Date: March 11, 2024

Addendum No. 3**Request for Proposal Call No. NRFP2024-027
CONSTRUCTION OF CENTURY GARDENS YOUTH HUB**

**ELECTRICAL ADDENDUM EA-3
CENTURY GARDENS COMMUNITY YOUTH HUB
342 VODDEN STREET EAST
BRAMPTON, ON
PROJECT NO.: 2205
MARCH 7, 2023**

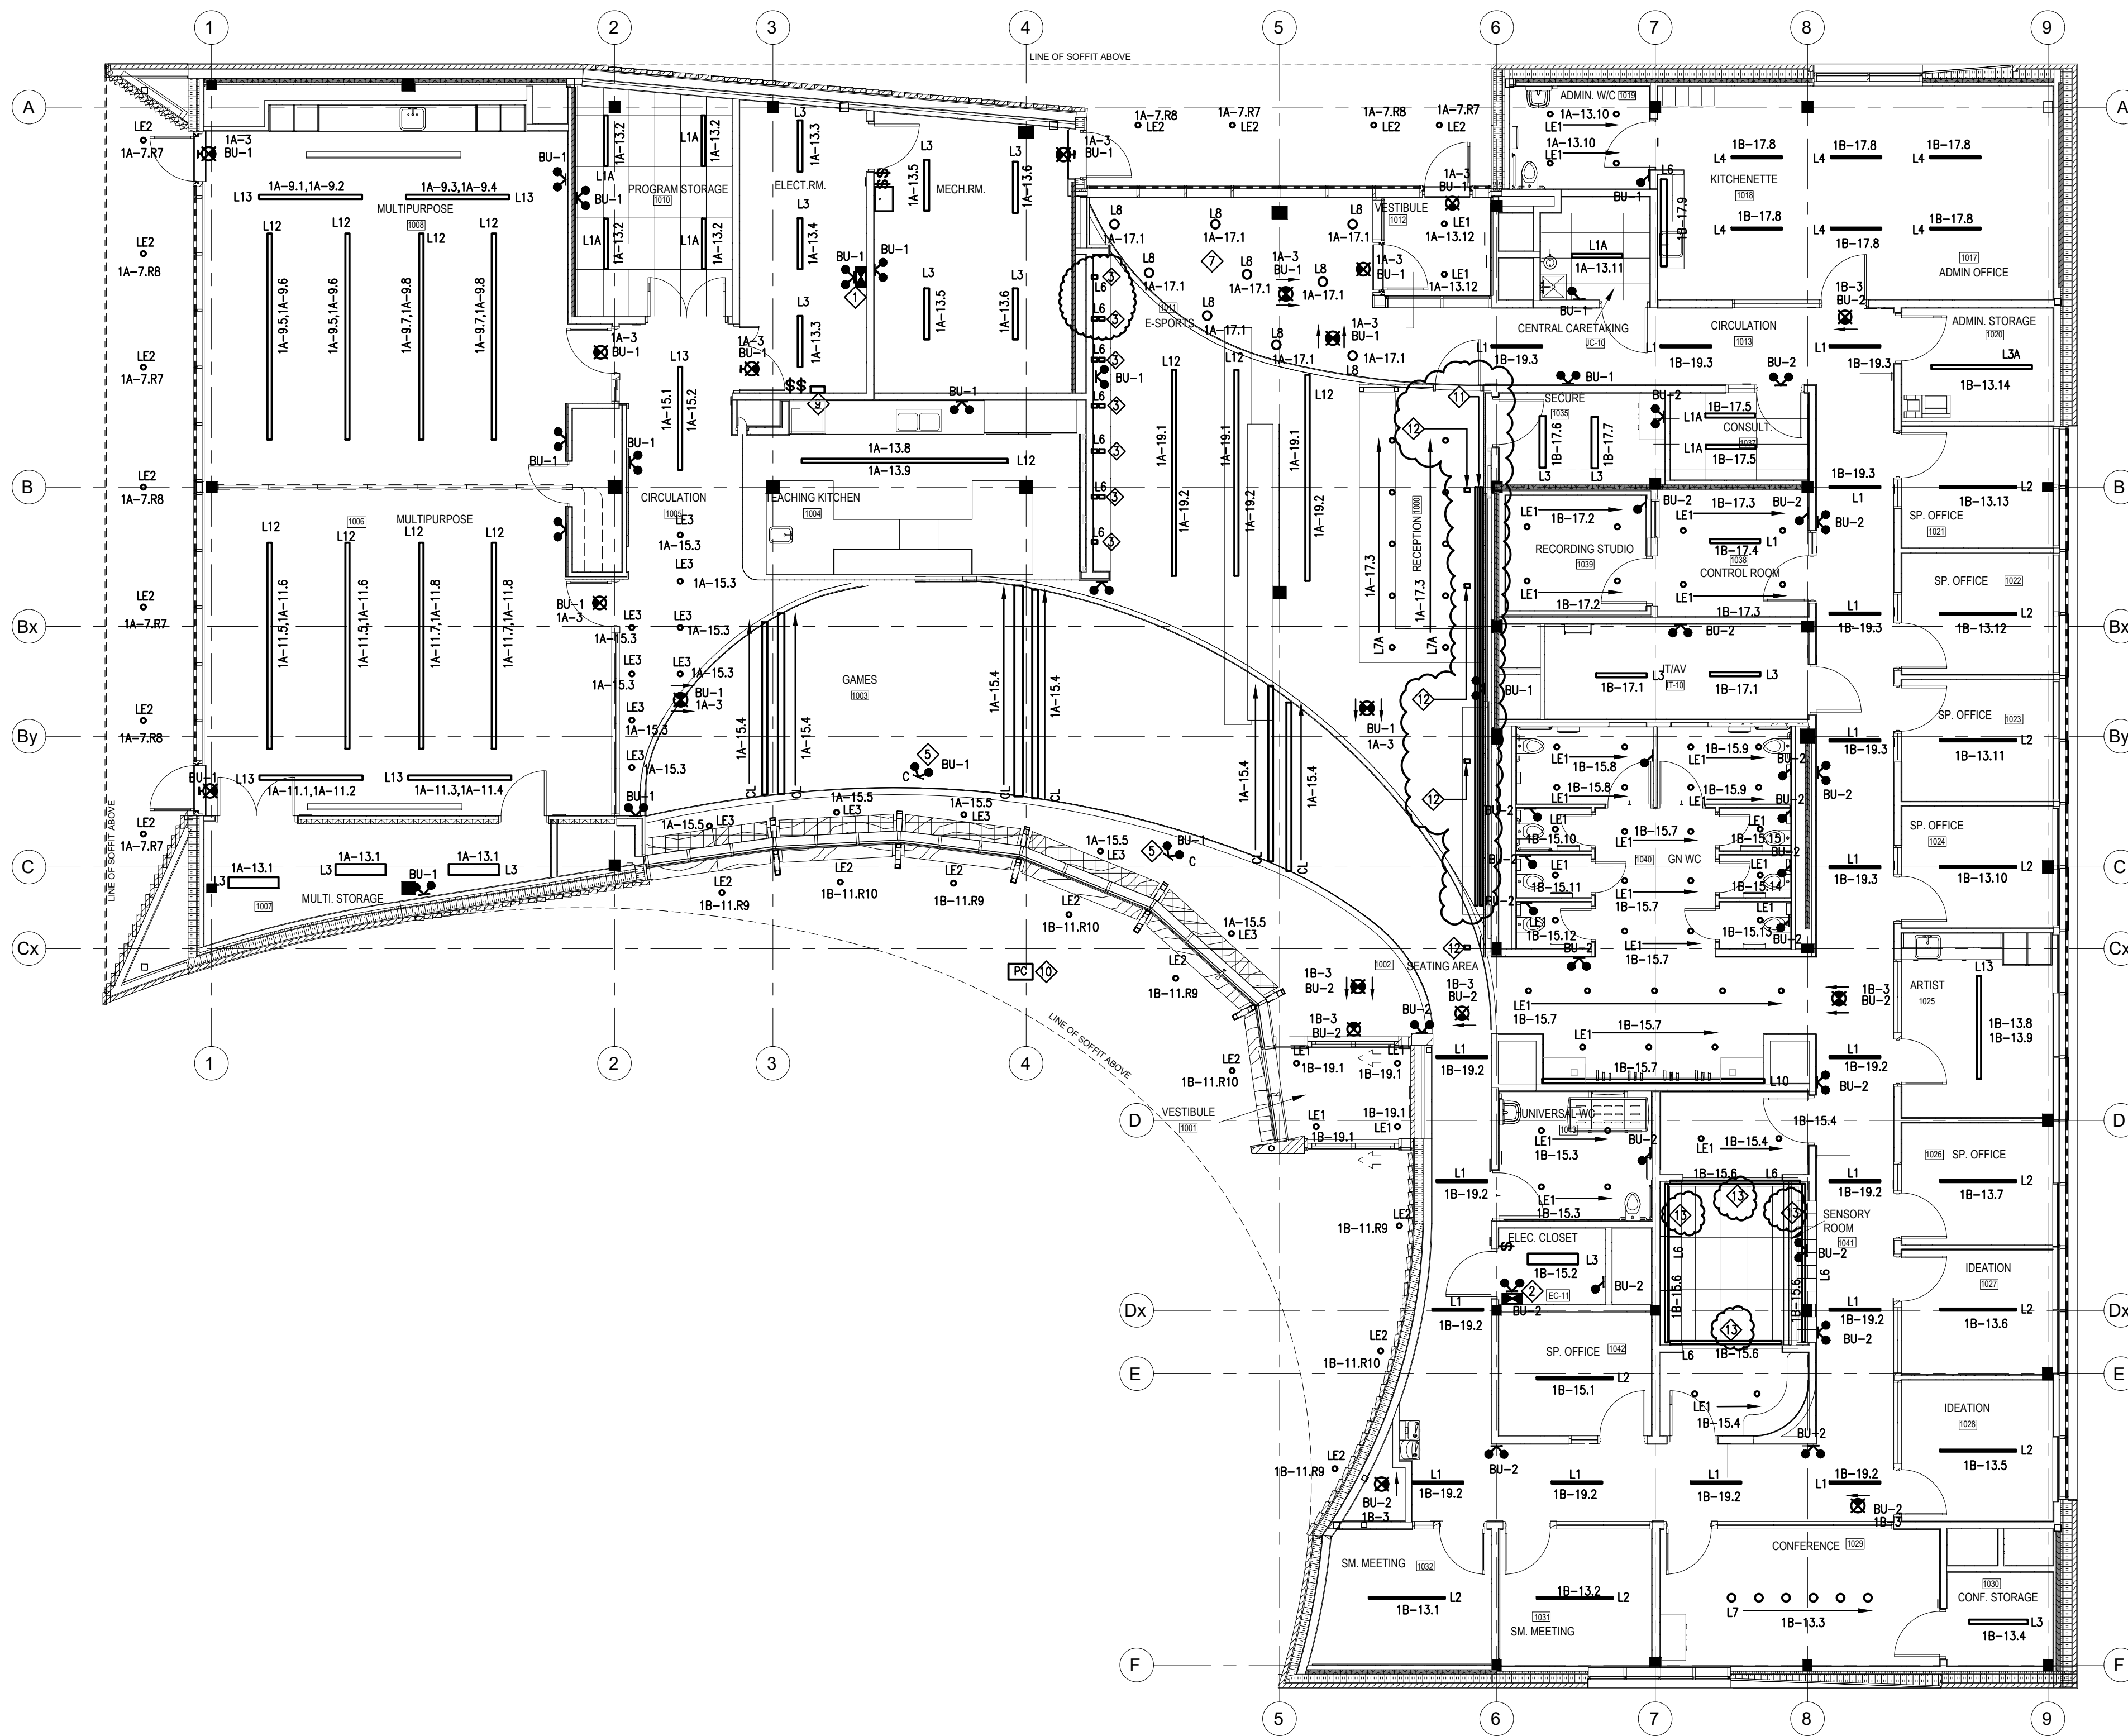
1. In drawing no.-E201, 'L3A' type light fixture is shown in Admin Storage Room. But there is no type 'L3A' light fixture given in the luminaire schedule given in drawing no.- E100.
2. In drawing no-E400, note 25 is shown near to metering legend in the single line drawing but there is no note no.25 shown in the drawing notes column.
3. There is no specification given the tender documents for the 225 KVA transformer shown in the drawing no. E400 .
4. The Digital metering system is provided by the system supplier according to the section 26 09 23 of the tender document. Please confirm the who is the system supplier, and it is not in scope of work of electrical contractor.
5. Please confirm the incoming breaker for distribution panel- DP-BB shown in drawing no.E400. There is no incoming breaker shown presently.

1. Revise Luminaire Schedule as per attached Drawing E100.

DRAWING TITLE
LIGHTING LAYOUT

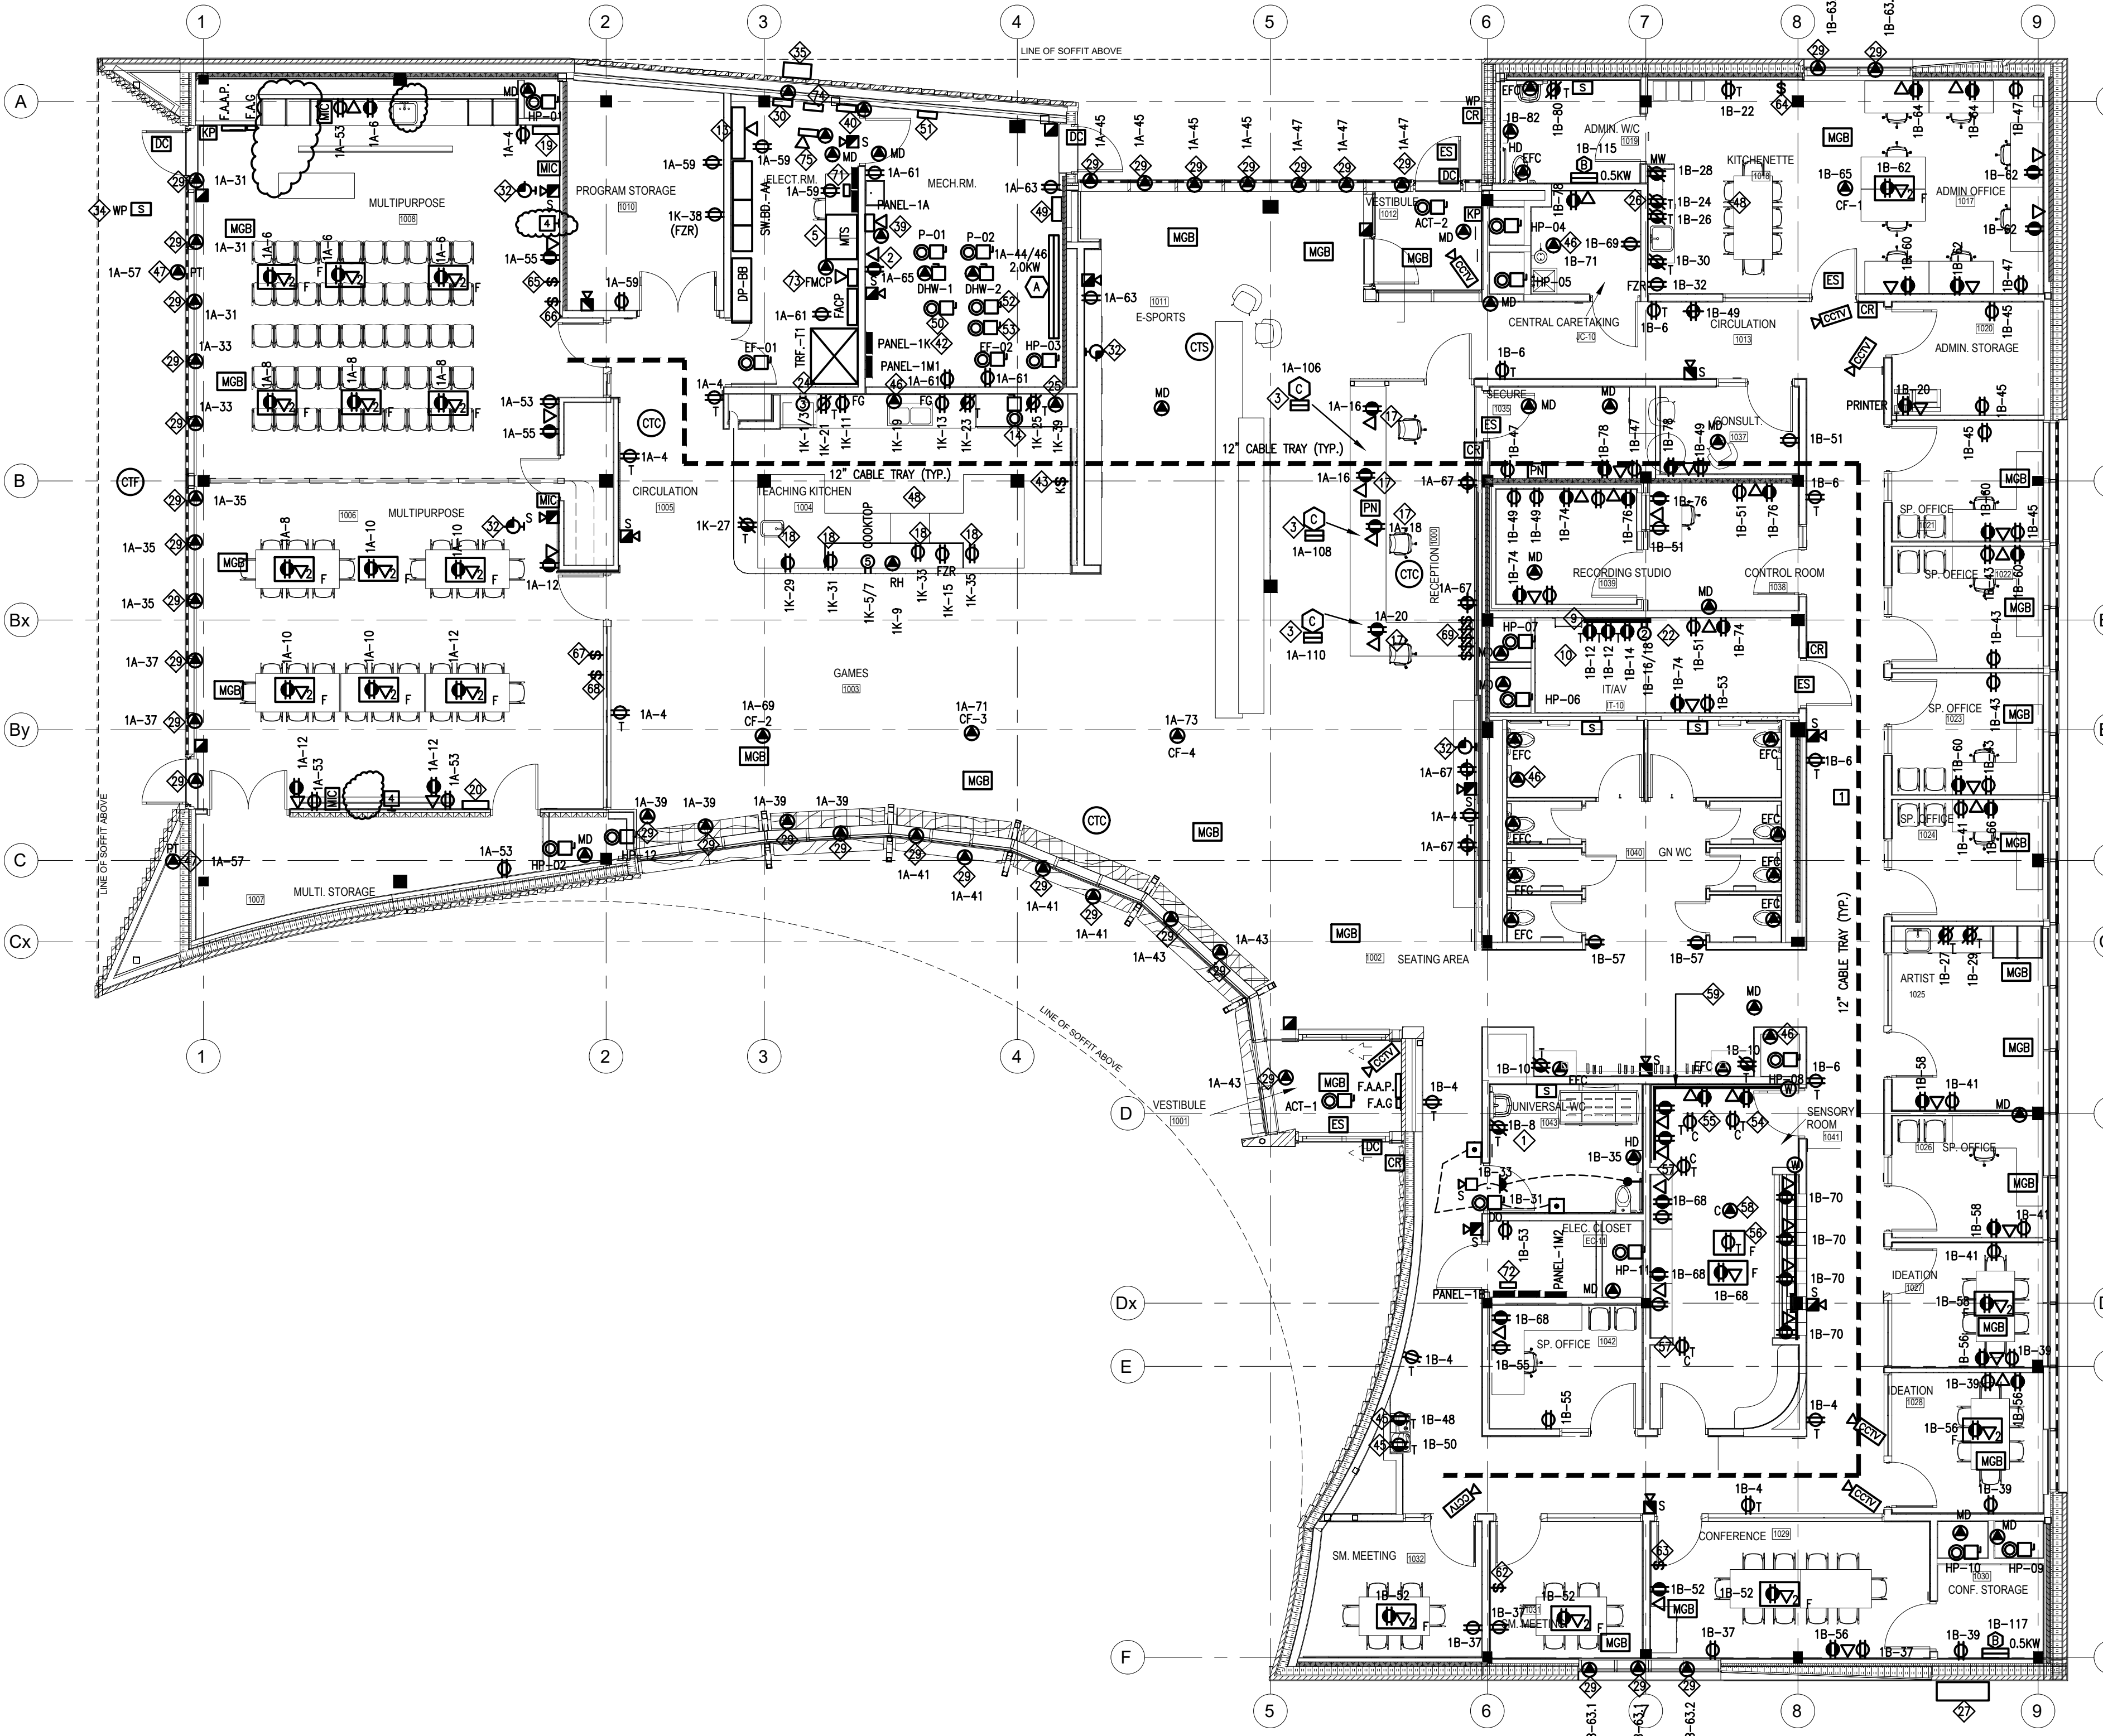
1. Revise Lighting Layout as per attached Drawing E201.

DRAWING TITLE
POWER & SYSTEMS LAYOUT

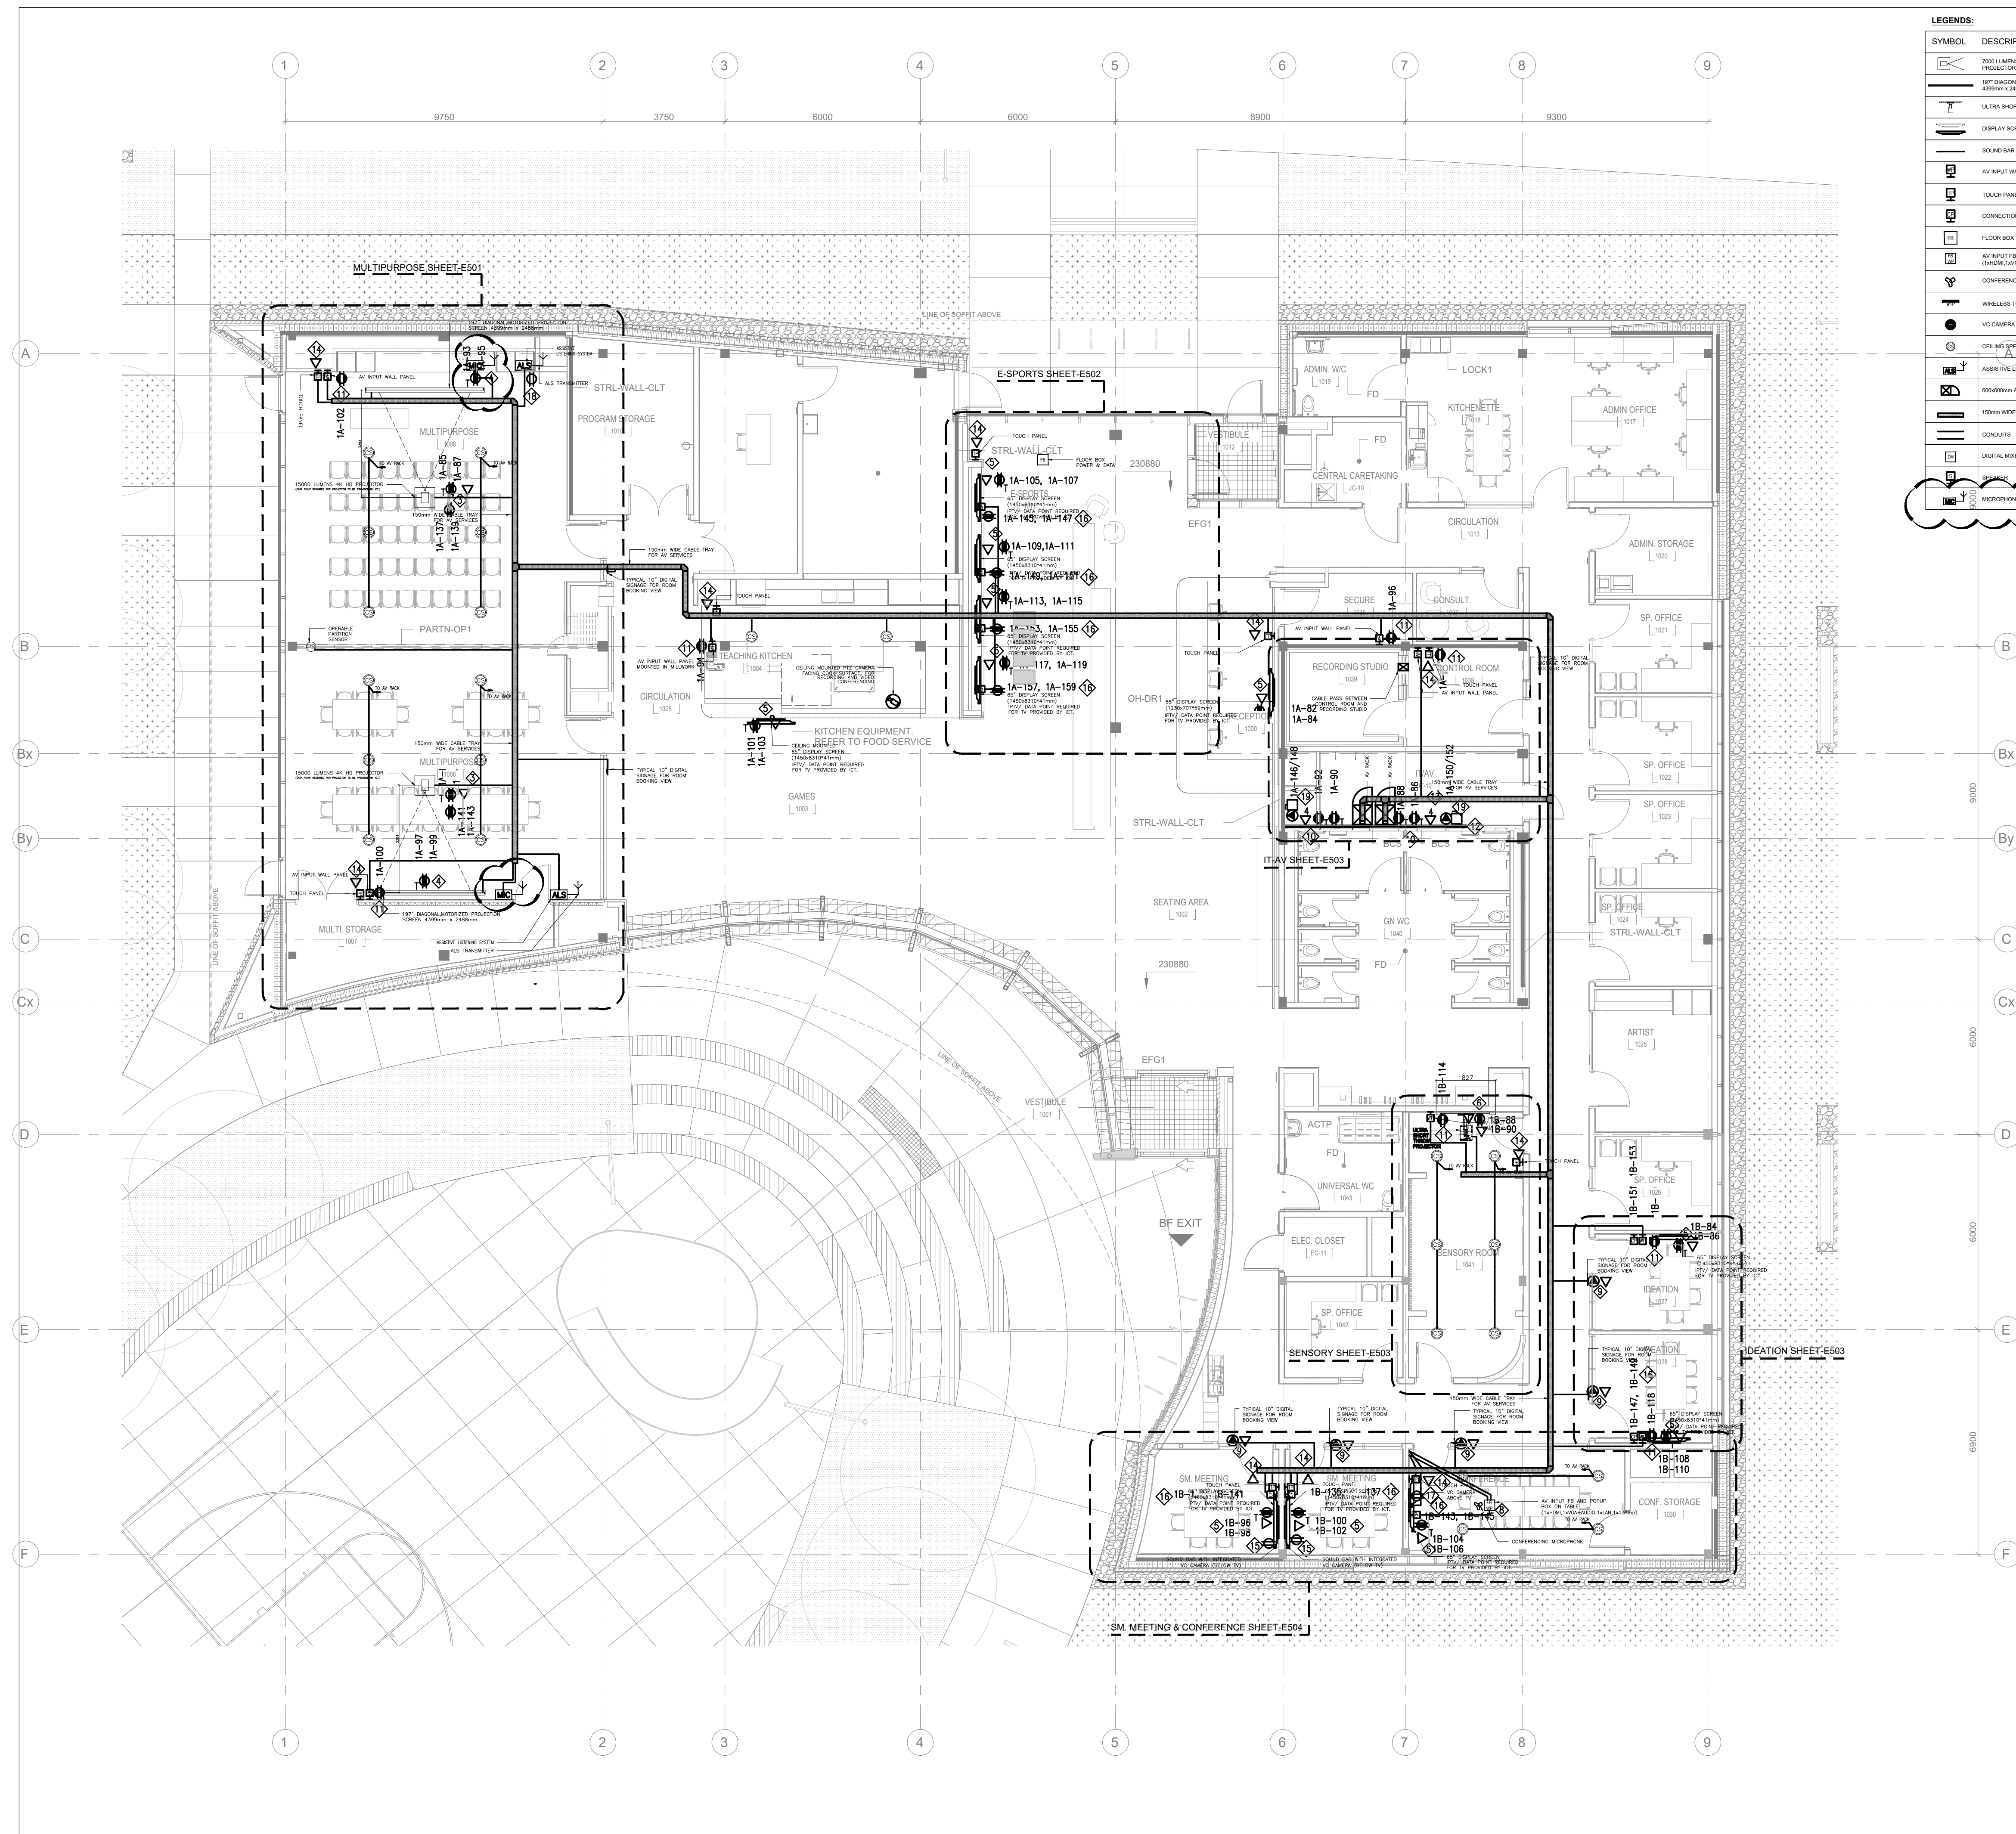
1. Revise Power & Systems Layout as per attached Drawing E301.
